UNITED STATES PATENT AND TRADEMARK OFFICE

10/587,367

Dieter Ramsauer

Office Action Summary	Application No. 10/587,367	Applicant(s) RAMSAUER, DIETER	
	Examiner KRISTINA R. FULTON	Art Unit 3673

Fig. 3.

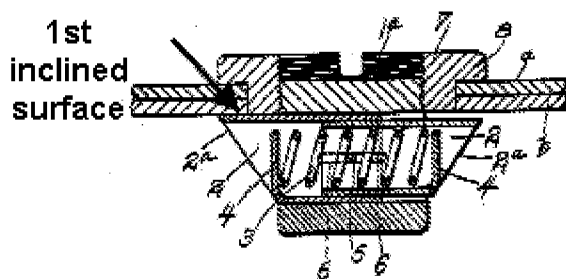
1. Claims 23, 26, 29-30 are rejected under 35 U.S.C. 102(b) as being anticipated by (Witzberger US 1426239).
2. Regarding claim 23, Witzberger teaches a snap fastening suitable for mounting in a thin wall (plates a,b) having a head part (8) arranged on one, outer side of the thin wall which overlaps an outer rim of the opening, a body part (1) which projects through the opening in the mounted position, holding elements (2) which project from the body

part and are resilient in a direction of the body part's outer surface against a spring force (3), a free end of the holding elements being provided with a first inclined surface (see figure below – Please note that “inclined” is defined as “tending in a direction that makes an angle with anything else” –source: Dictionary.com. Therefor without a reference the surface as labeled below can be considered inclined. Further, please note that if applicant intended to claim that the surface is inclined with respect to the wall; please see applicant's provided art 883121 where surface 22 is at an incline. Please note that 883121 is used for support and is not part of the rejection) for supporting the body part without play on the rim wherein the first inclined surface rests on the rim of the opening in the mounted position wherein said free end of said holding elements being further provided with a second inclined surface (2a) for slam action, said body part, holding element and spring generating the spring force being separate parts; wherein the holding elements are slides displaceable in the cylinder of the body part parallel to the plane of the thin wall; the slides are held against a pressure spring force (3) by a hook arrangement (slots 6 hook onto pin 5).
